January 26, 2022

Re: Third Peer Review
Comprehensive Permit Application
Mallard Lane, Bolton MA

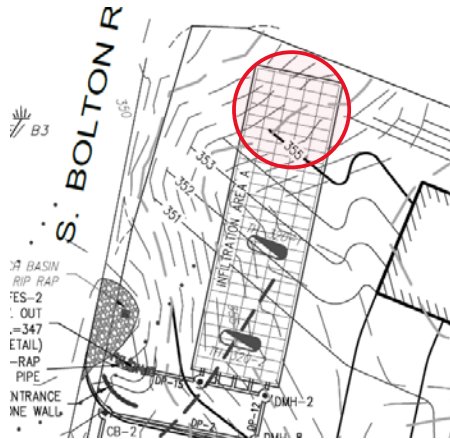
- e) There appears to be only 2.5-feet of cover over several pipes. HW recommends that the Applicant confirm that this is adequate for loading under pavement and that the drainage structures will be able to be constructed with inverts at the proposed elevations.

HW 1/26/22: The Applicant has specified ductile iron pipe for drainage pipes 1 and 2 with 2-feet of cover. It appears that there is actually less than 1-foot of cover over these pipes at the structures. HW recommends that the Applicant confirm that this is adequate for loading under pavement and that the structures will be able to be constructed with the inverts at the proposed elevations.
